1A & 1B VALLEY ROAD
59 - 63 TRAFALGAR AVENUE
LINDFIELD

SSD APPLICATION - DESIGN REPORT

APPENDIX AP6. RTS RFI RESPONSE

RESIDENTIAL AMENITY - SOLAR EXISTING CONTEXT

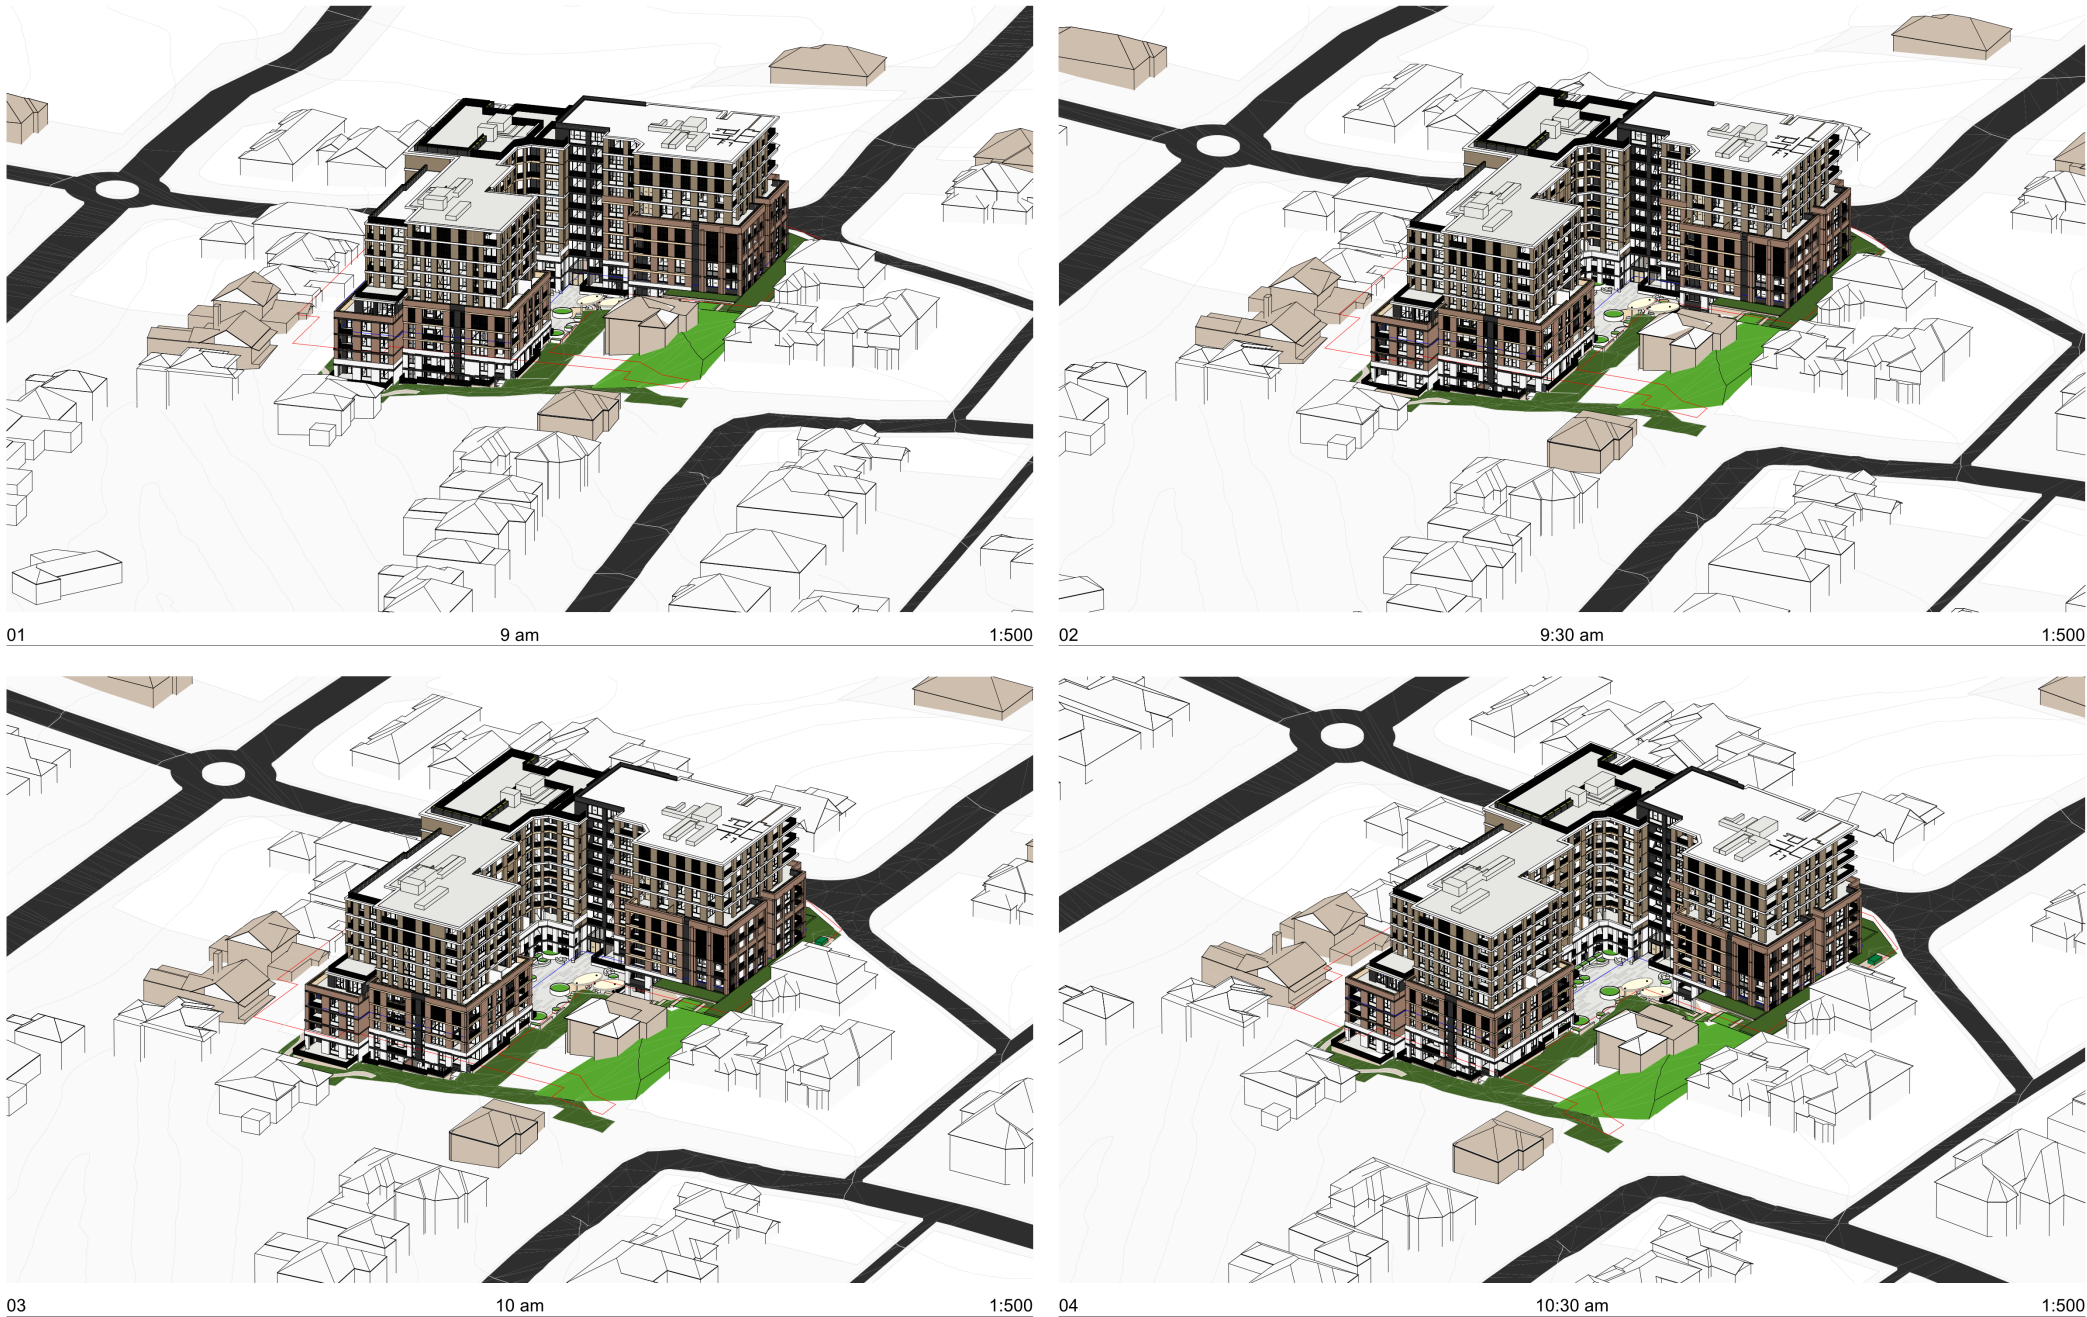
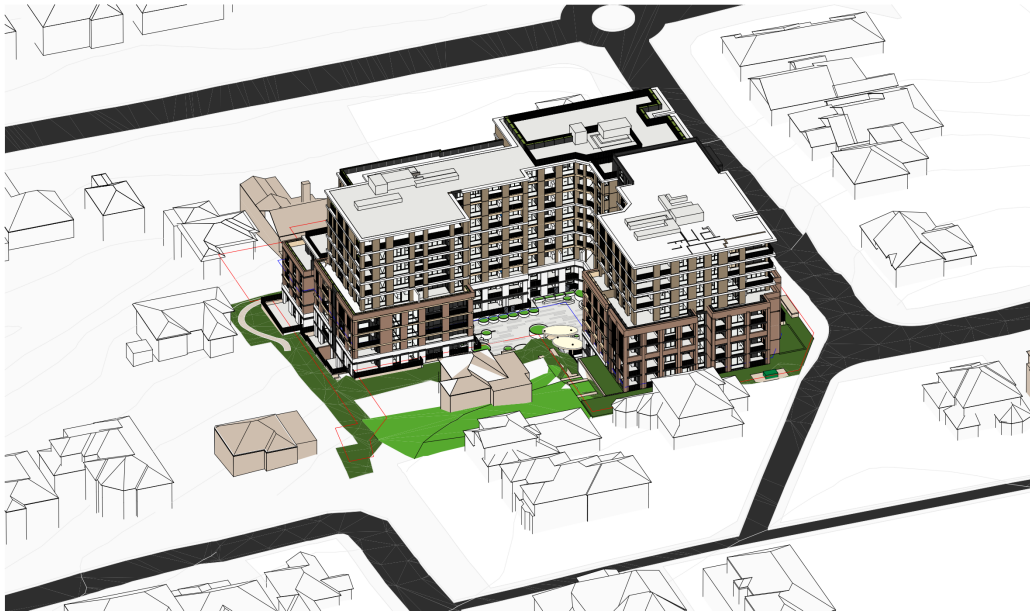
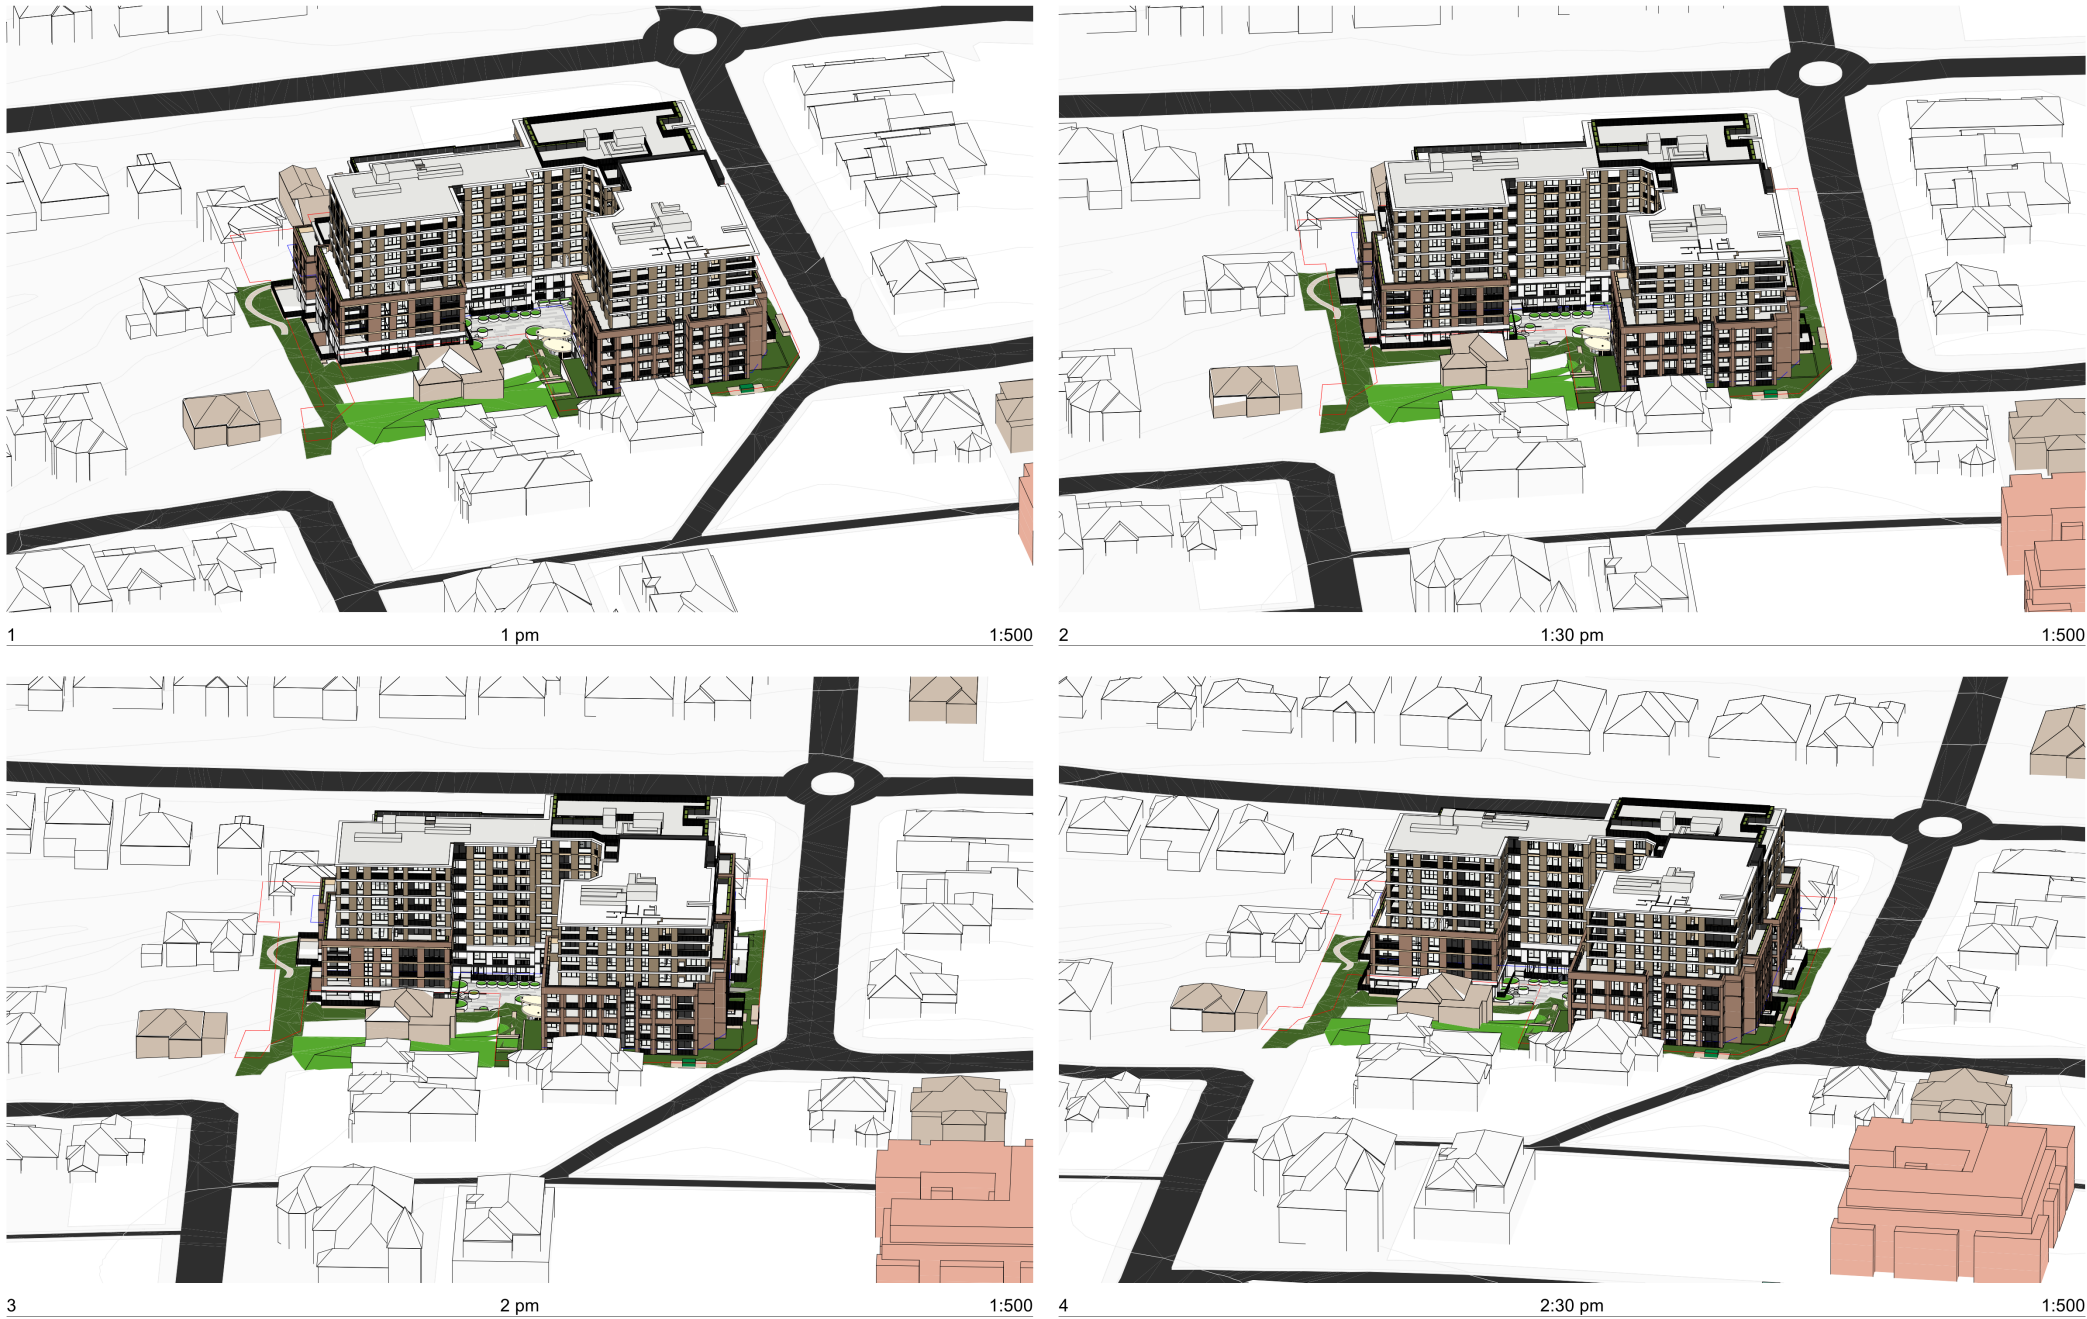
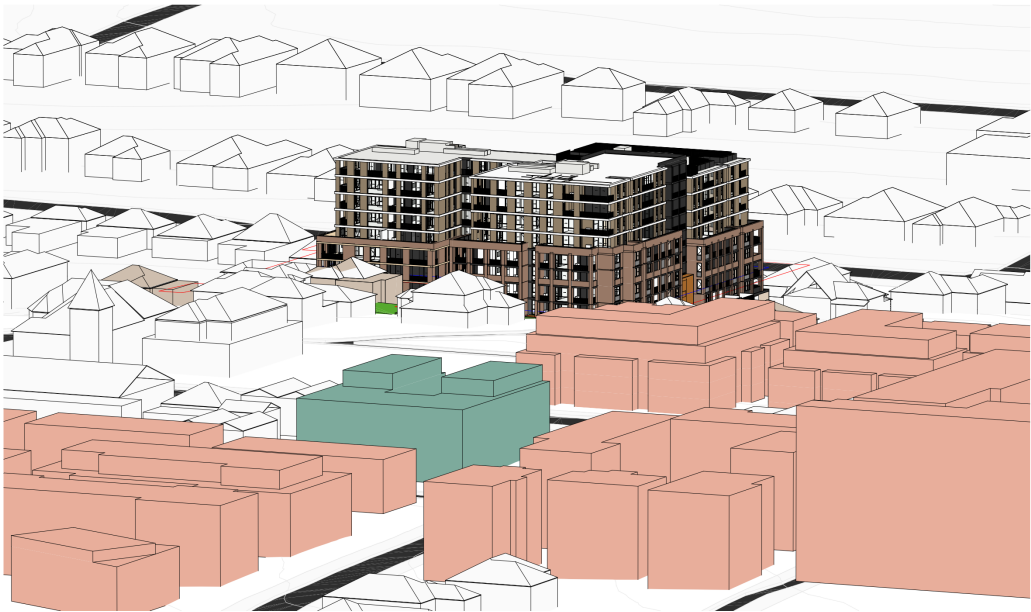
- a. Provide an updated solar access study, including hourly shadow diagrams and views from the sun to demonstrate the impacts of the proposal in mid winter on the surrounding development in the following scenarios:
 - existing low density development
 - Council’s final scheme
 - LMR controls (where relevant).

Updated sun eye view diagrams have been prepared to illustrate and compare the solar access and shadow impacts between the existing low-density context, Council's proposed draft scheme, and the LMR controls where relevant. The analysis demonstrates that the shadow impacts consistent with what would otherwise be expected from built forms developed under the TOD and appropriately respond to the surrounding development context.

RESIDENTIAL AMENITY - CORE

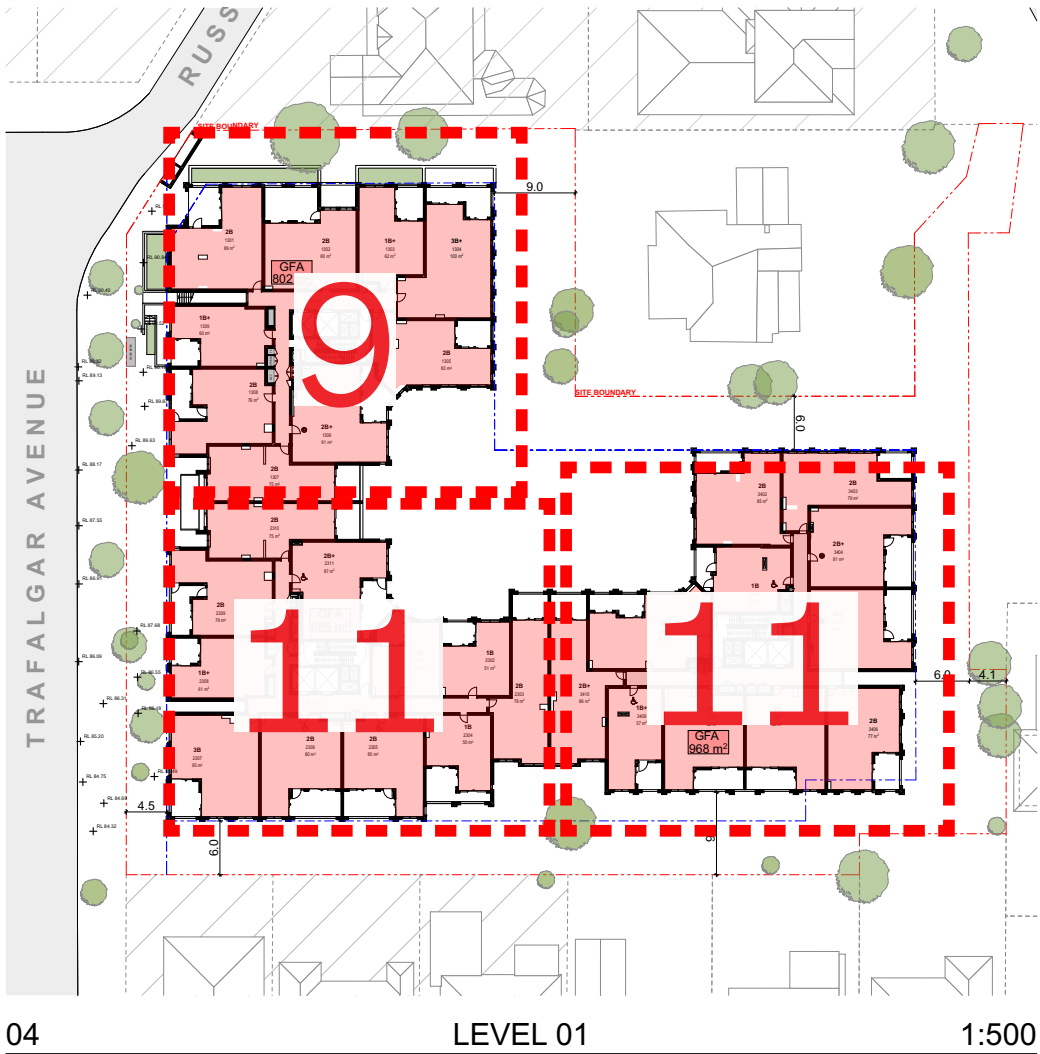
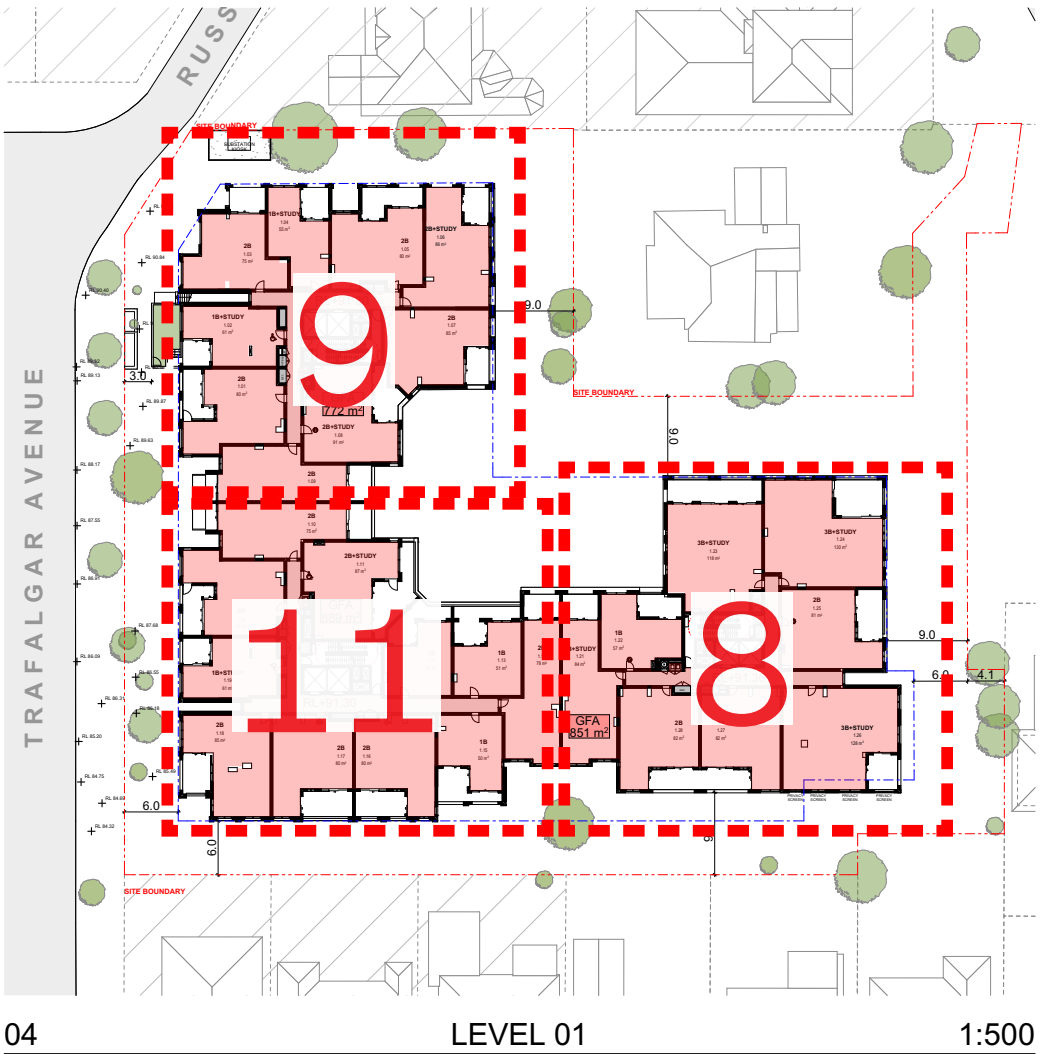
Circulation core

RESIDENTIAL AMENITY - CORE

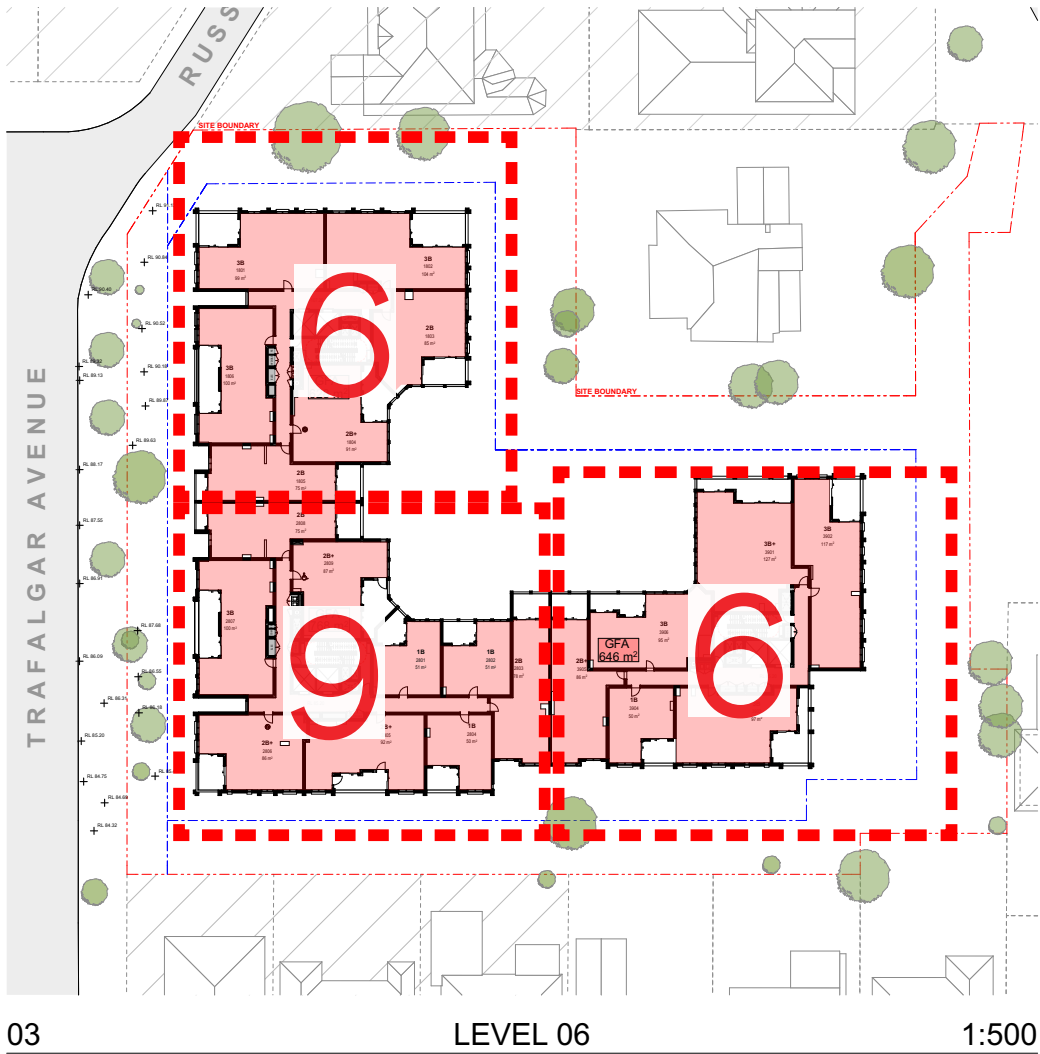
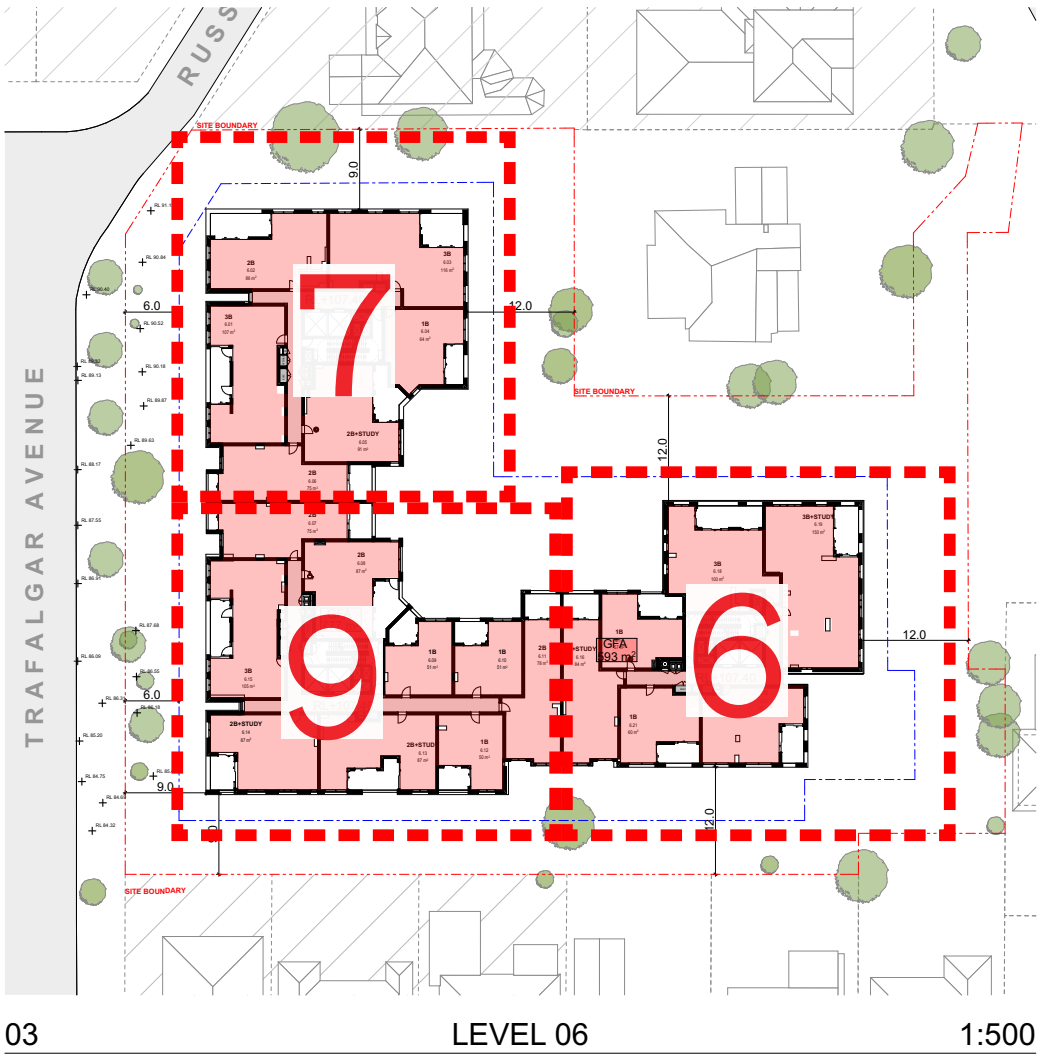
Circulation core
